Deviation Request ETSO-C159d#1 for an ETSO approval for CS-ETSO applicable to Next Generation Satellite Systems (NGSS) Equipment (ETSO-C159d)

Consultation Paper

2 ETSO-C159d#1 Next Generation Satellite Systems (NGSS) Equipment

Figure E1-2: AES Requirements Map

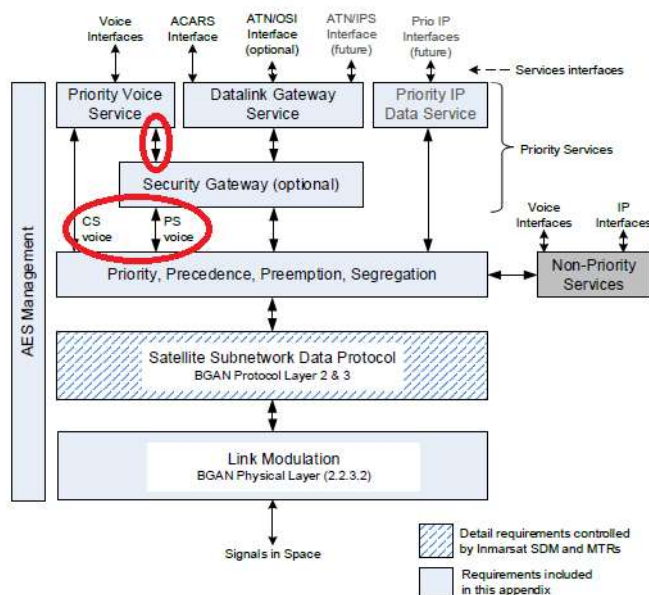
DO-262D version introduces Enhanced PS Voice through the Security Gateway, in addition to the Datalink services (ACARS, ATN/OSI ...) already defined in DO-262C. The schematic below, extracted from DO-262D Appendix E Section 1.3.8 illustrates the new material (Note: PS Voice mentioned on the below figure deals with Enhanced PS Voice, not standard PS Voice as stated in Appendix E Section 2.2.1.3).

In comparison with DO-262C where PS Voices are processed with a VOIP function that packetize the call to IP packets, the DO-262D configuration transmits VOIP packets to security gateway. Then, the security gateway adds a VPN encapsulation header to the IP packets and transmit it to the Inmarsat network. As explained in DO-262D Appendix E Section 1.3.4, Enhanced PS voice service is added to the security gateway, CS call is not impacted since it cannot be routed through the security gateway. PS Voice traffic definition is the same from DO-262C to DO-262D, just adding the Enhanced PS Voice to the Security Gateway. Additionally, the Enhanced PS Voice service is protected by the IPSec/IKE authentication on the Security Gateway (same as ACARS). Routing the Enhanced PS Voice through the Airborne Security Gateway (ASGW), named Security Gateway in Figure E1-2, has no impact on the traffic definition as the ASGW functions are authentication only. ASGW does not impact traffic types, it is transparent at this level.

CS call is managed outside the security gateway and Datalink uses a dedicated traffic flow since data packets containing ADGW messages are sent through a dedicated priority background PDP context. Both services, CS call and datalink, are managed on the same way as DO-262C requirements and DO-262D only affects the Enhanced PS Voice. CS and datalink services are not impacted due to this change.

As demonstrated in paragraph 2.3.1, DO-262D changes the routing of the Enhanced PS Voice, IP packets, over the security gateway (For information, standard PS Voice path remains identical to DO-262C as stated in Appendix E Section 2.2.1.3). That can imply:

Due to the difference between DO-262C and DO-262D, the PS Voice will be unavailable in case of security gateway failure. Consequently, users on ground and on board the aircraft must be informed that PS Voice is no more operative. Both DO-262 revisions have the same Appendix E paragraph 4.1.3 requirement regarding system operational indication.

Due to the difference between DO-262C and DO-262D, the PS Voice will be unavailable in case of security gateway failure. In case of PS Voice unavailability, "Loss of Voice" safety objective shall remain achievable. For clarification, loss of voice capability means loss of both CS Voice and PS Voice.

Adding the PS Voice to the security gateway, the IP packet processing time for the PS Voice is increased. The IP packet size increases since the IP packets for the PS Voice are encapsulated to provide the authentication required on the security gateway. The latency for performing the IP packet including the VPN header processing is sub milliseconds.

In order to ensure, at least, the same level of safety, the applicant shall add an additional requirement demonstrating that SATCOM users are well informed in case of PS Voice unavailability.

In order to ensure, at least, the same level of safety, the applicant shall add an additional requirement demonstrating the "Loss of Voice" safety objective.

In order to ensure, at least, the same level of safety, the applicant shall add an additional requirement demonstrating that the system has sufficient provisions to support the new functionality (total cycle time/memory/resources).

- Demonstrate that SATCOM users are well informed in case of PS Voice unavailability,
- Demonstrate the “Loss of Voice” safety objective,
- Demonstrate the system latency for PS Voice is in accordance with Inmarsat SDM requirement,
- Demonstrate that the system has sufficient provisions (total cycle time/memory/resources).
